<b>Application Number:</b>	<b>AWDM/0693/23</b>	<b>Recommendation - APPROVE: to delegate to the Head of Planning and Development to grant planning permission subject to completion of a satisfactory section 106 Agreement, Revised Development Framework Documents and responses from the drainage consultee</b>
<b>Site:</b>	<b>Land North of Beeches Avenue, Worthing</b>	
<b>Proposal:</b>	<b>Outline planning application for residential development of approximately 90 dwellings, associated car parking, open spaces and landscaping, with primary access from Lyons Way and approximately six of these dwellings accessed via Beeches Avenue and improved pedestrian footpath link to Charmandean Lane; also rationalisation of car parking provision at the existing football ground</b>	
<b>Applicant:</b>	Hargreaves Residential Developments Ltd	Ward: Offington
<b>Agent:</b>	Rob Huntley Planning Consultants	
<b>Case Officer:</b>	Stephen Cantwell

## Proposal, Site and Surroundings

**Figure 1: Green Infrastructure**

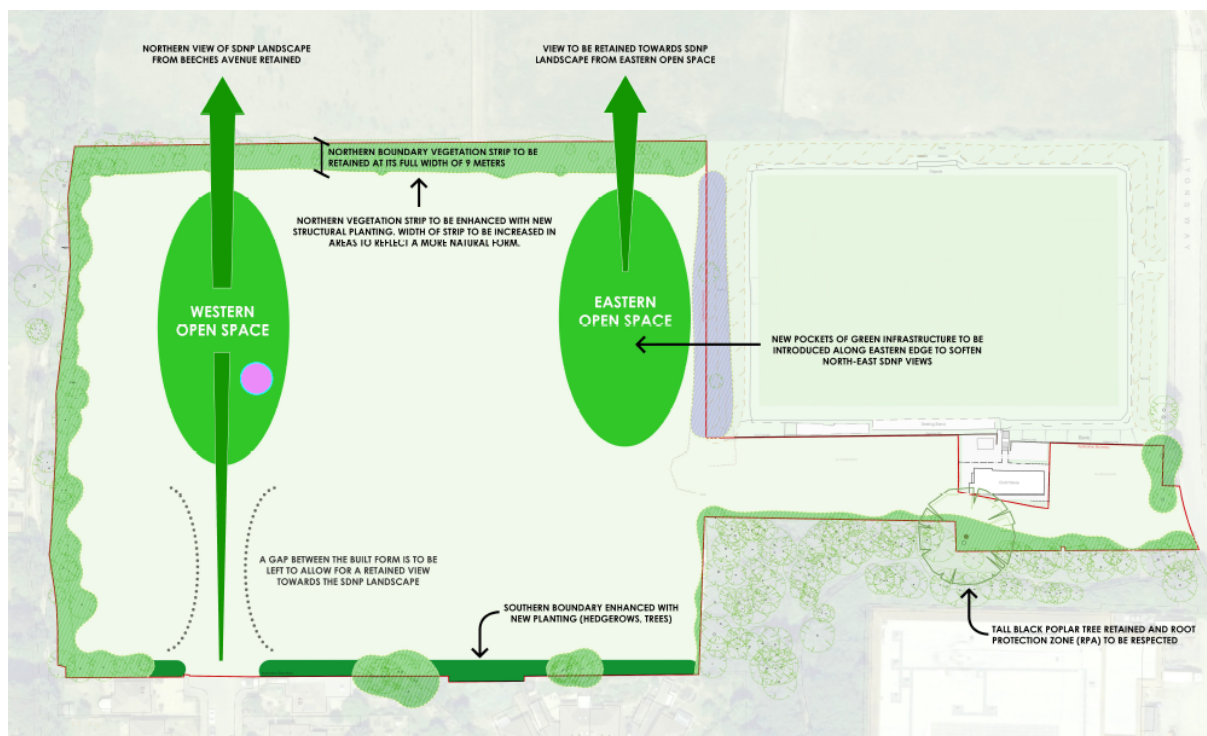
The proposed Green Infrastructure Parameter Plan indicates new and existing vegetation around the perimeters with enhanced planting. An expanded note can be added to ensure that new planting at the eastern includes informal clusters, the effect of which will filter and punctuate the view of buildings and roofs to the west of the space. A note is to be added to ensure that the hedgerow at the western boundary is also retained, as part of the relationship to Charmandean Lane and neighbours in Fourth Avenue.

Protected trees at the football club frontage and its southern boundary are retained and planning conditions would manage construction methods to safeguard these.

The two open spaces are broadly located on this plan. Their views into the National Park are indicated; another eastward view can be added. It is important to quantify these spaces in the Parameter Plan to ensure that they are adequately sized in the future Reserved Matters layout.

**Figure 2: Character Areas**

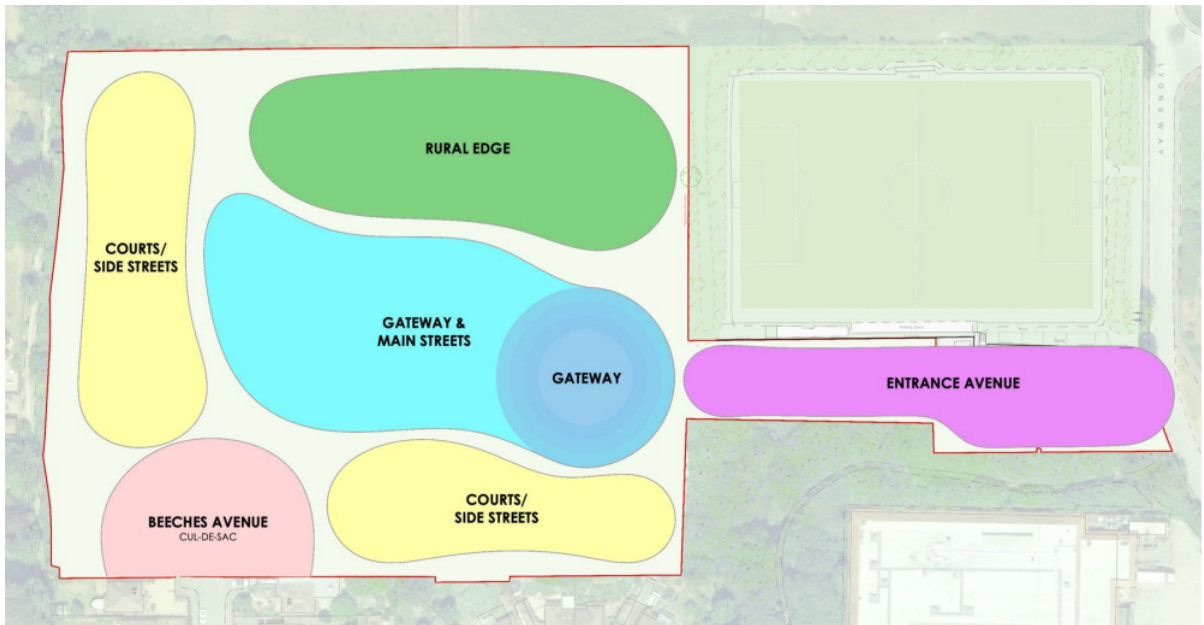
One observation is that an adjustment is needed to the Character Area Parameter Plan in order to incorporate open space areas of the Green Infrastructure Plan. A similar change is needed to the Density and Height Parameter plans, which appear at the end of this section.

Figure 3: Heights

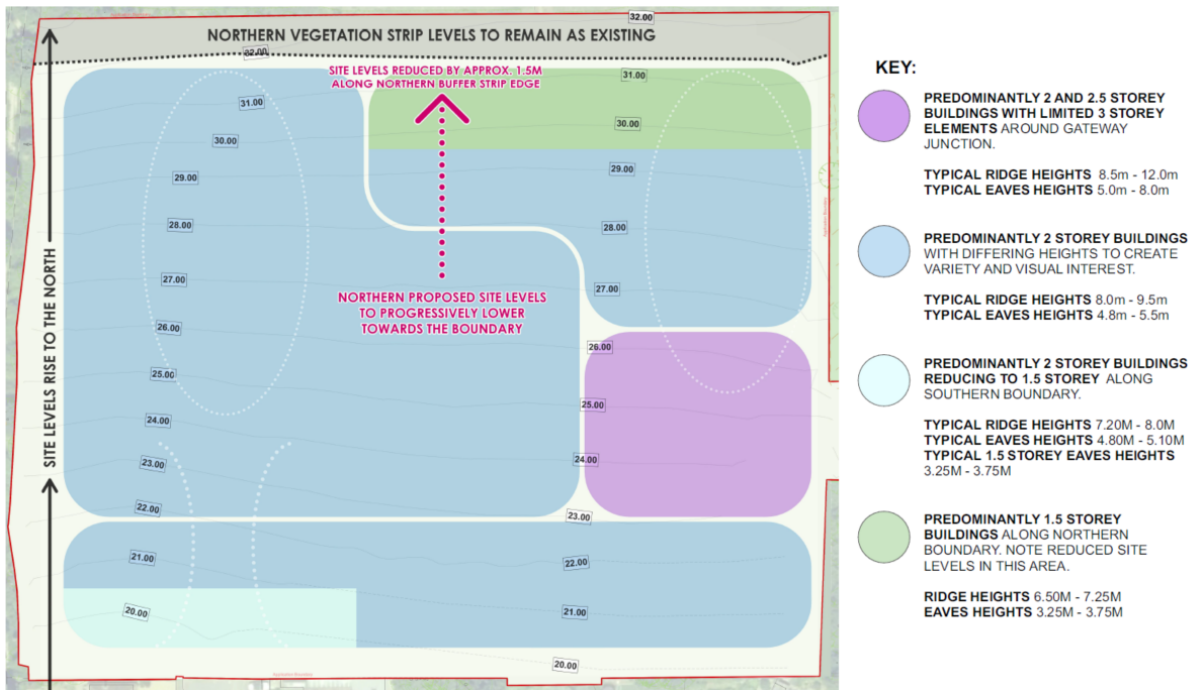
The Height Parameter Plan (Figure 3) indicates that site levels will be reduced by approximately 1.5m along the northern buffer strip but ensuring that this does not impinge on the double-hedgerow.

**Figure 4: Densities**

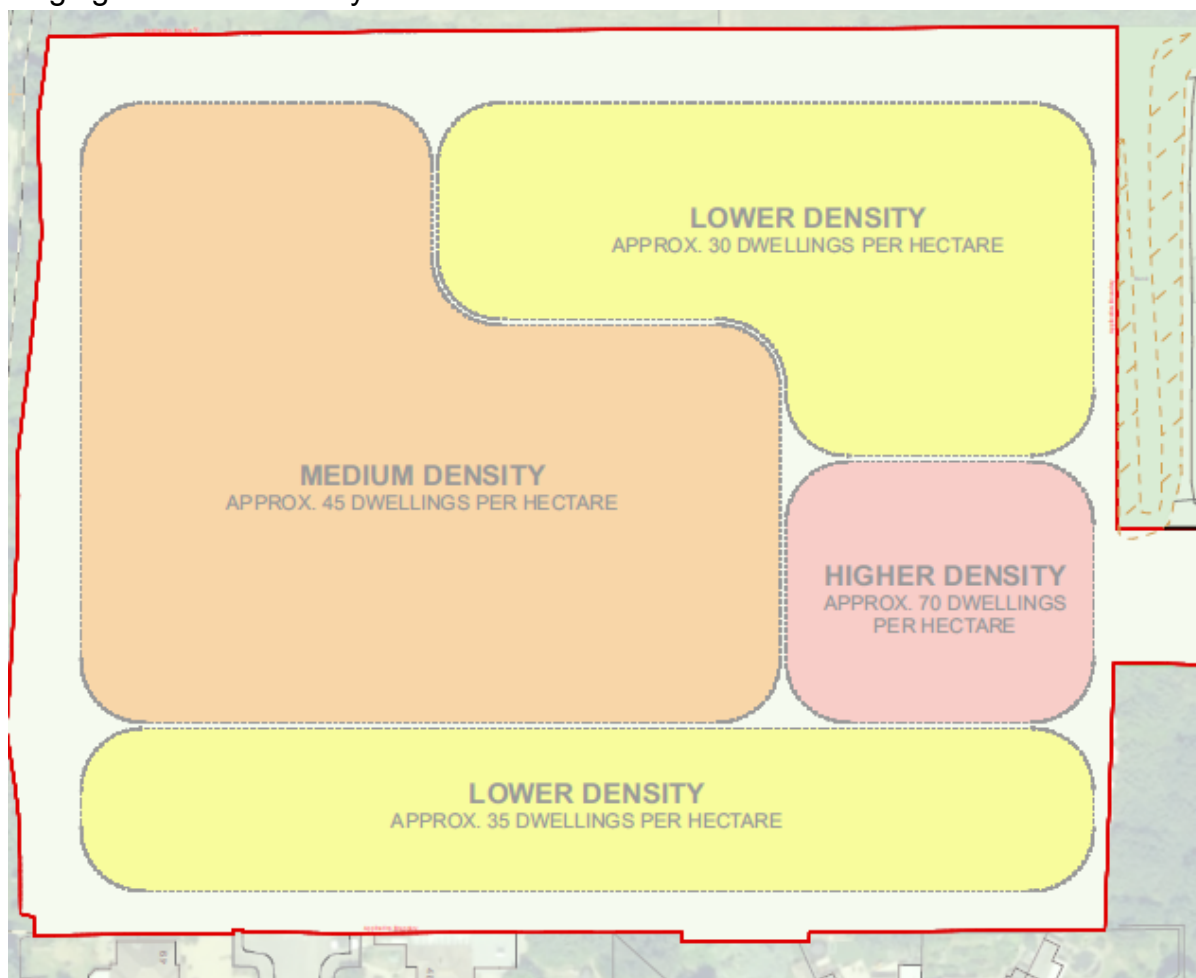
In the anticipated revision of these Parameter Plans to accommodate open spaces, it is probable that the average net density will increase when open spaces are deducted from the developable areas. Policy DM2, which states a minimum 35/ha net density, is sufficiently flexible as to allow for this.

It is also important that confirmation is provided that the resulting change in density can still deliver a layout of buildings, spaces and masses which broadly accord with the illustrative plan. This is necessary in ensuring that the landscape and neighbouring relationships are realistic and can be delivered at the Reserved Matters stage.

Figure 7: Illustrative Plan

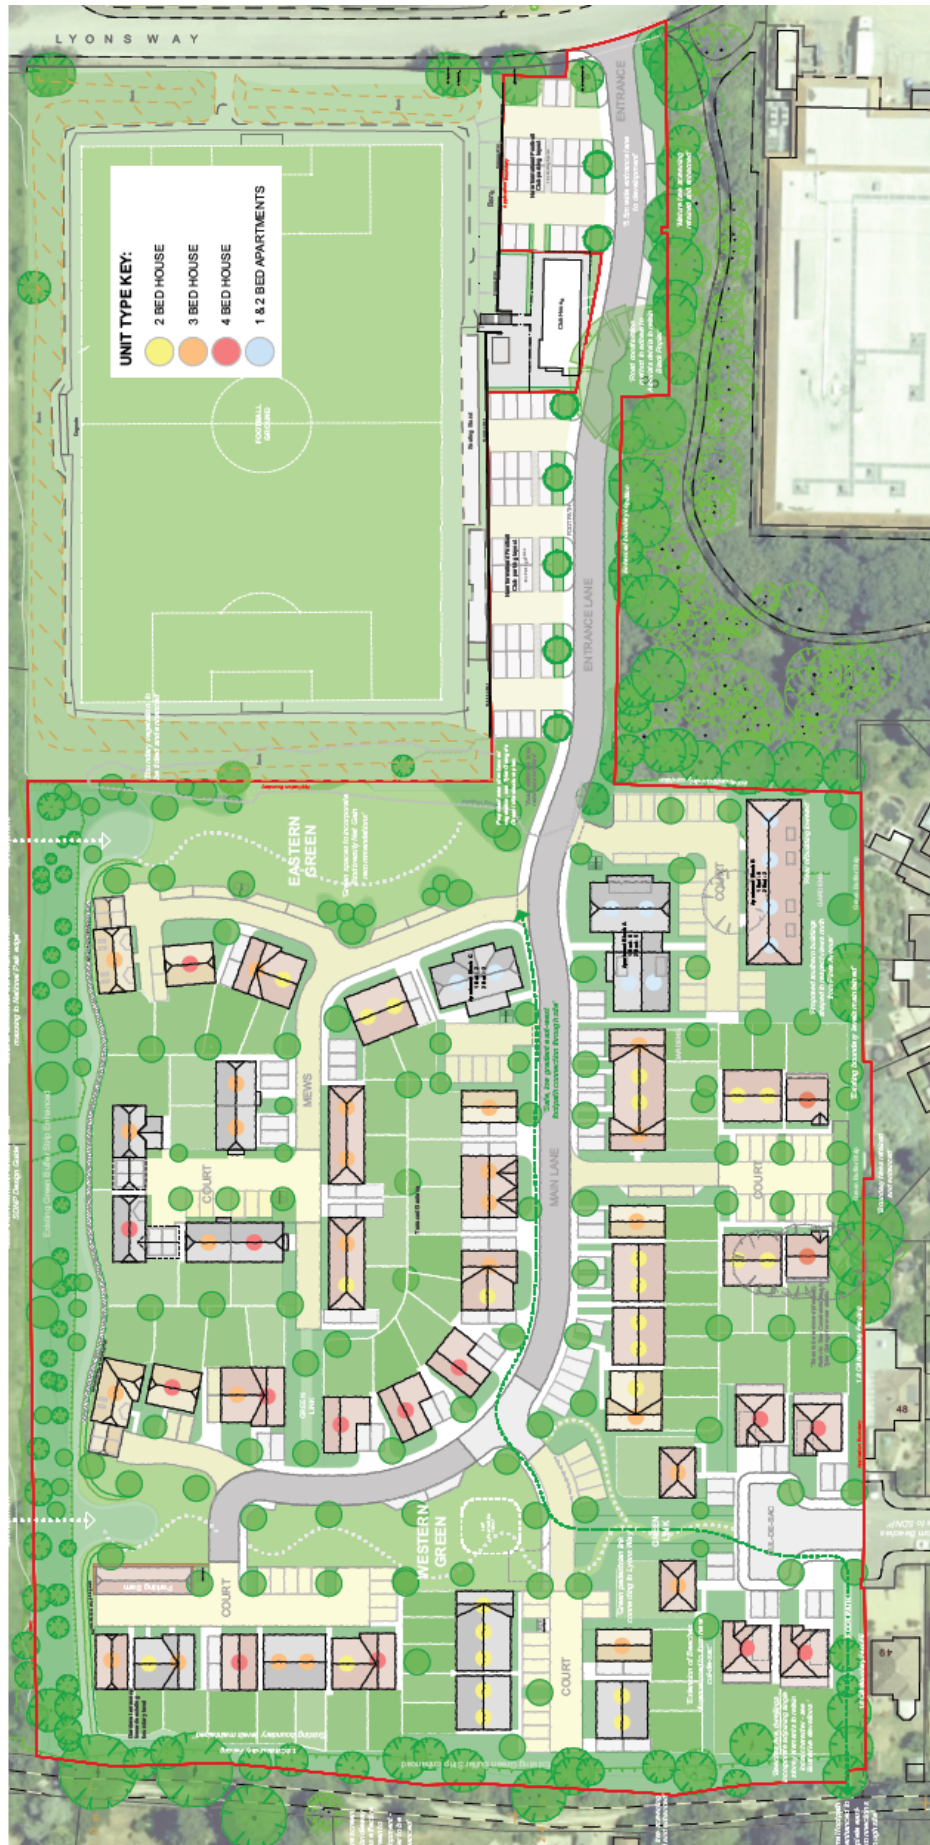
The illustrative plan (Figure 7 below) shows a possible layout of 90 dwellings comprising 67no. houses and 23no. apartments. The apartments are clustered in the gateway and southern court area. In this layout two storey apartments in the southern court area are 11m from the boundary with bungalows in Pines Avenue, giving an overall separation of 19m between buildings. Whilst some ground lowering and buffer planting is indicated, the distance is less than desirable and the relationship should be carefully planned at the reserved matters stage.

Some gardens and separations elsewhere are less than desired, for instance 17m rear to rear separations instead of 20-21m in parts of the main streets area. One solution may be to reduce the overall number of buildings by using a greater proportion of apartments in the development mix. This also indicates that it may be difficult to achieve a higher number of dwellings than the 90.no shown here without placing greater pressure on areas such as open space and upon the question of parking provision.

At Beeches Avenue, buildings are well spaced and show a balance of green space (front gardens) with in-curtilage parking. Although there is a greater presence of parking than in the existing street, the gap between buildings which maintains the vista to the National Park edge, is well spaced. At the reserved Matters stage, care will be needed to ensure that its value is not eroded.

As already mentioned, care will also be needed in the placing of the footpath link to Charmandean lane, and its associated landscaping, in order to balance the accessibility benefits with the amenities of the existing neighbour.

**Figure 8: Access & Movement**

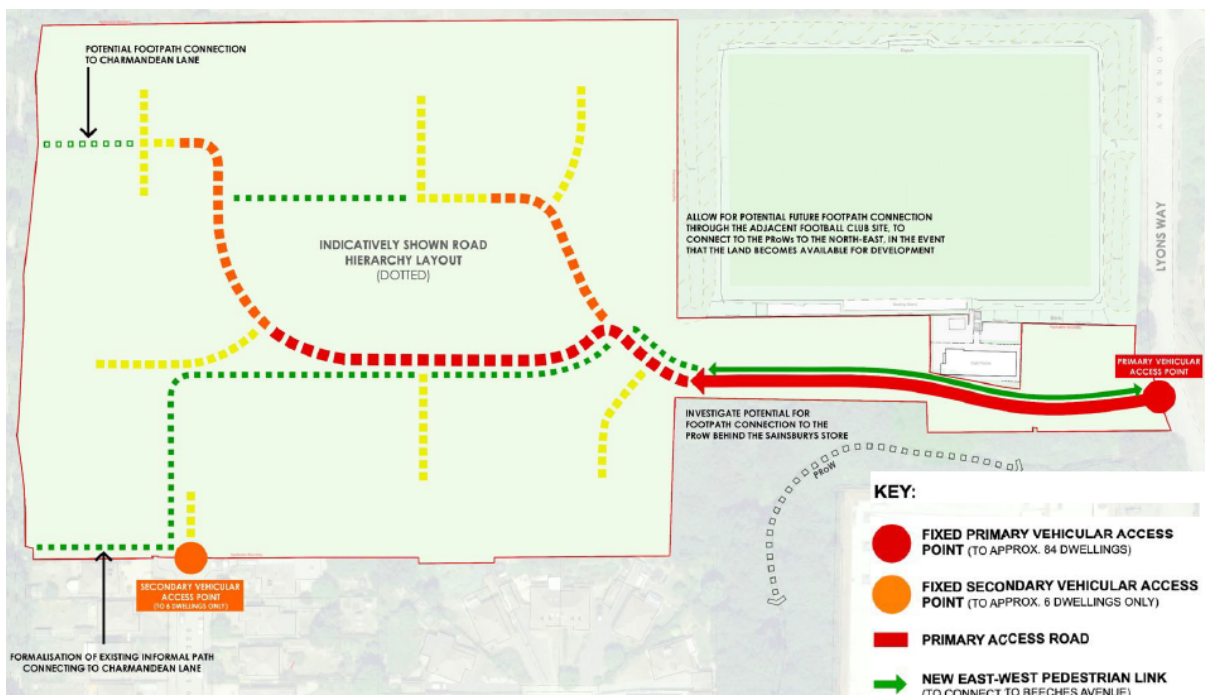
Within the site the indicative routes are shown by dotted lines (red = primary, orange = secondary and yellow = tertiary). Roadside footways would run alongside the primary and tertiary roads. Tertiary side streets and courtyards would include shared surfaces and parking courtyards.

Pedestrian only routes are shown in green. The dotted lines in the bottom left-hand corner of the Movement Plan reflects the proposal to formalise the existing informal link here to the Public Right of Way (PROW) in Charmandean Lane. This would link to Lyons Way through new footways across the application site. The other PROW (FP3134) at the northern end of Lyons Way, can be reached via these new pedestrian routes.

Another, indicative pedestrian route is shown connecting to Charmandean Lane to the top left ( north), which, if achieved, could link to another indicative footpath along the northern edge of the site, which is indicated in the illustrative plan but not shown in Figure 8.

**SUPP. 2 Density Parameter Plan (above)**

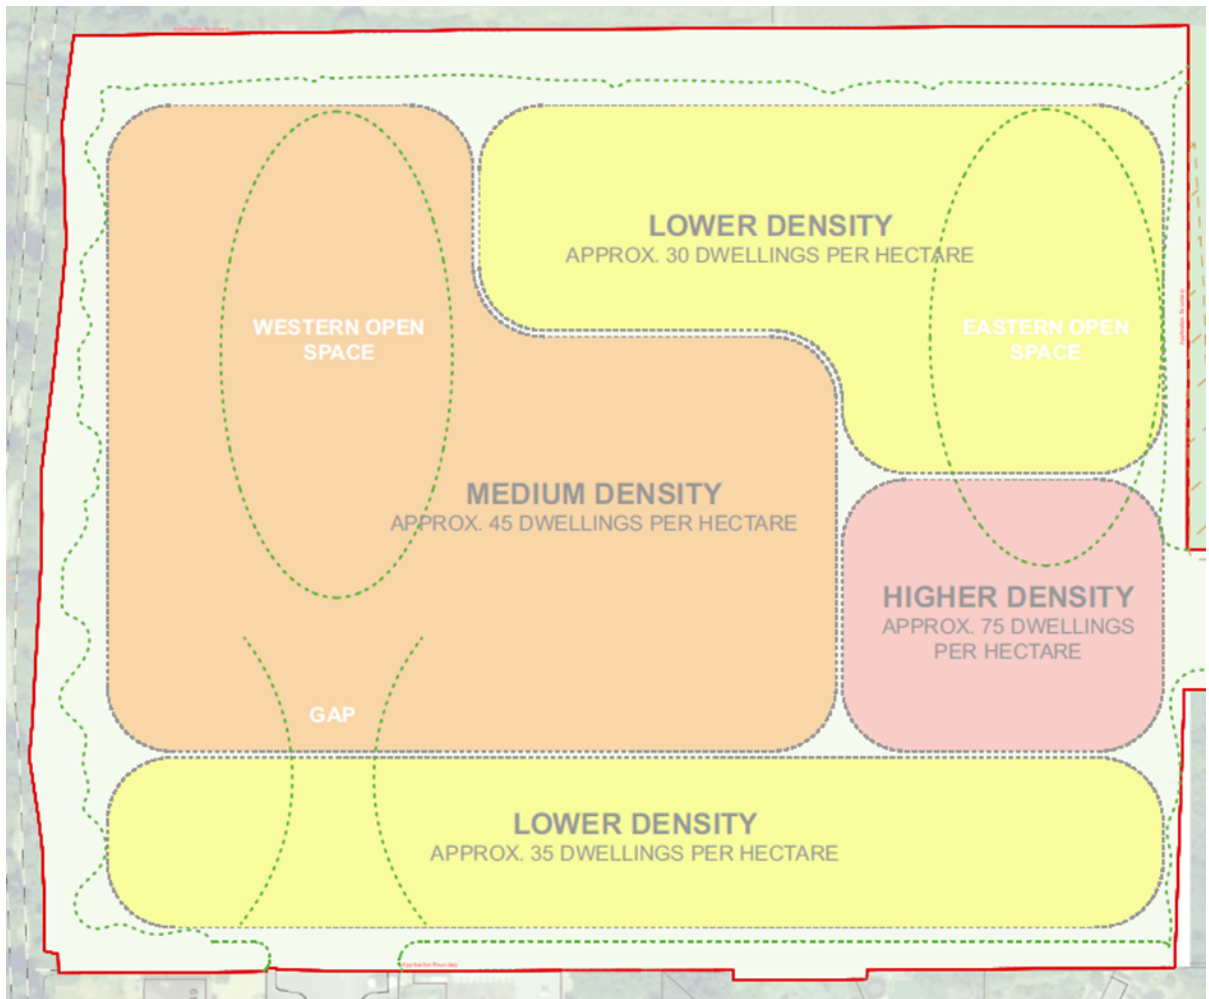
The density parameter plan below, has added in indicative locations of open space at the east and west of the site. This is helpful, although it could be interpreted at the Reserved Matters stage as allowing for built forms within the broad locations where these spaces are to be located. It could be strengthened by a visible annotation which stress the importance of locating the open spaces in these locations.

**SUPP. 3 a & b Green Infrastructure Parameter Plan  
(above and below)**

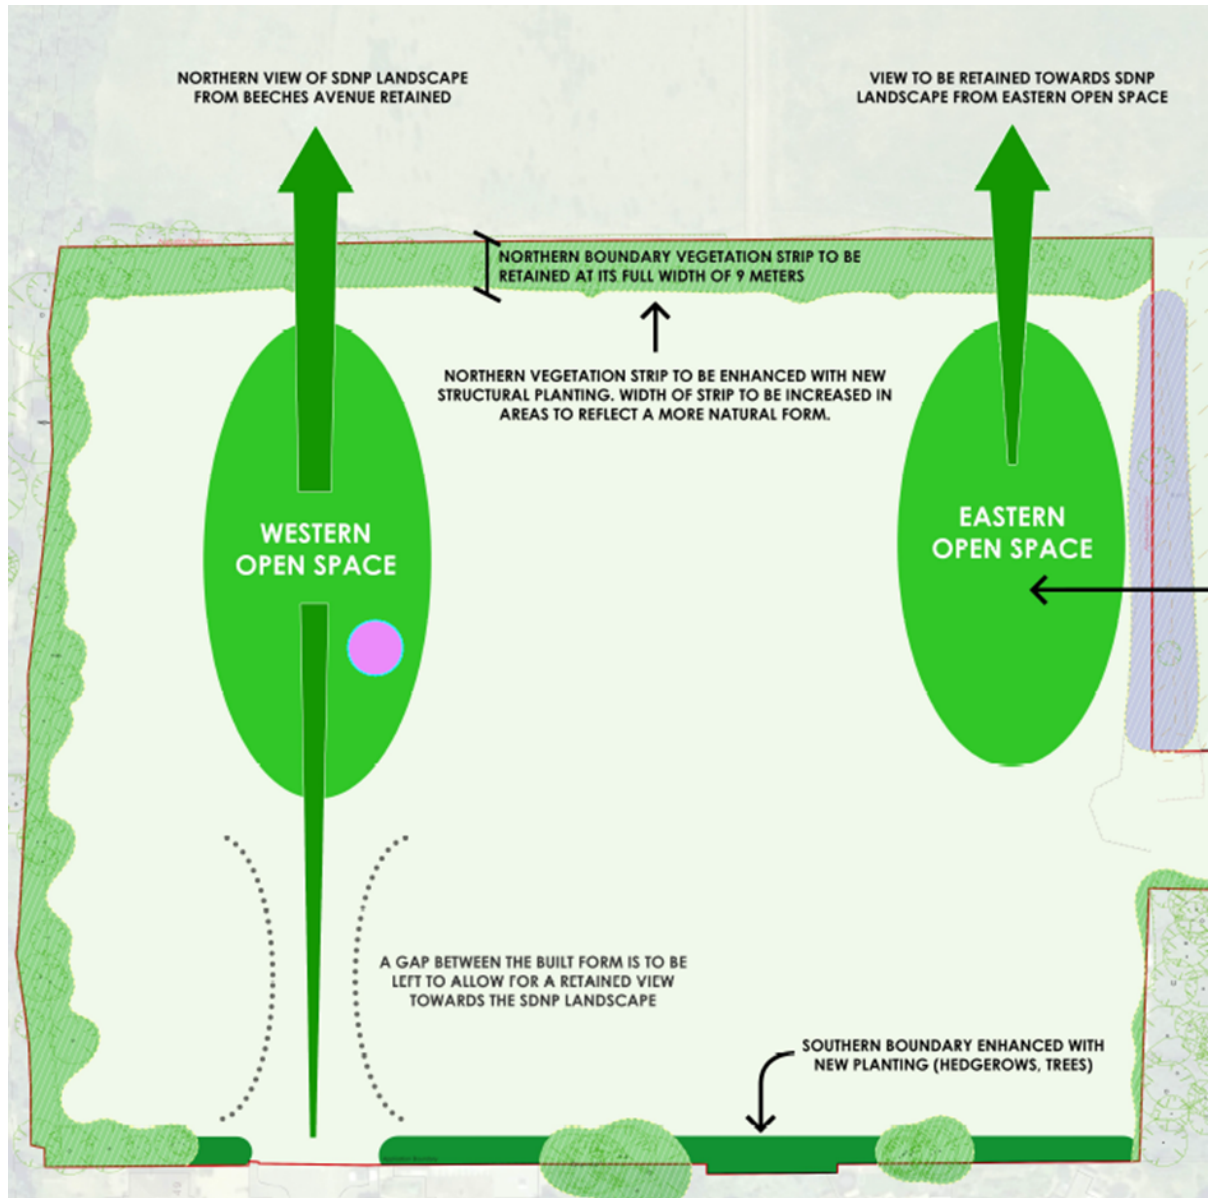
The two segments of the amended Green Infrastructure Parameter Plan below include additional annotations to make more explicit the proposal for additional planting as part of landscaping to the north and east and buffers to the south and west. It would be important at the Reserved Matters stage, that they are accessible for maintenance.
